Re: Comments and Hearing Request Regarding Lennar Homes of Texas and
Jeanette R. Morris and Bobbie J. Neff Application for TPDES Permit No.
WQ0016660001- Broken Cedar Ranch Wastewater Treatment Facility

1. **Background:** Lennar Homes of Texas Land and Construction, Ltd., together with
co-applicants Jeanette R. Morris and Bobbie J. Neff, has applied to the Texas
Commission on Environmental Quality (TCEQ) for a new Texas Pollutant Discharge
Elimination System (TPDES) permit (Permit No. WQ0016660001) to authorize the
discharge of treated domestic wastewater at a daily average flow not to exceed
600,000 gallons per day.

Figure 1: Location of Groundwater Wells from Proposed Broken Cedar Ranch WWTF

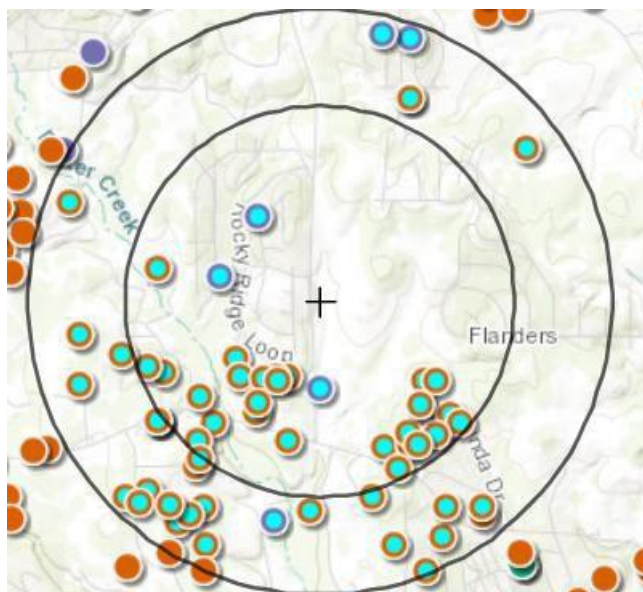
B. Impacts on Surrounding Groundwater Wells and Aquifer Protection: According to the Texas Water Development Board (TWDB), 63 water wells were found to be within a 1.5-mile distance of the Broken Cedar Ranch WWTF, with 32 wells found to be within a mile distance of the Broken Cedar Ranch WWTF (Figure 1). Water well data was pulled from three TWDB groundwater databases: TWDB Groundwater Database (GWDB) reporting 7 wells in the 1.5-mile distance area, Submitted Drillers Reports (SDR) Database reporting 56 wells in the 1.5-mile distance area, and Brackish Resources Aquifer Characterization System (BRACS) Database reporting 0 wells in the 1.5-mile distance area².

Further examining the stated water well data, 56 out of the 63 wells were noted to be used for domestic (household), irrigation, or public supply purposes. The volume of wells located in this close proximity to the facility, discharge point, and route poses a serious concern of cross-contamination with the local groundwater supply that these well owners rely on to meet their needs. Many private wells are not subject to routine water quality monitoring, and well owners rely on groundwater as their primary source of drinking water. The intermittent nature of the receiving stream, combined with the density of nearby wells, raises concerns regarding potential groundwater vulnerability, particularly in areas where

Additionally, GEAA notes that the application does not include a site-specific evaluation of groundwater connectivity, losing-stream conditions, or well vulnerability along the discharge route. GEAA requests that TCEQ carefully consider the proximity of groundwater resources and ensure that permit conditions adequately protect aquifer resources and private well users.
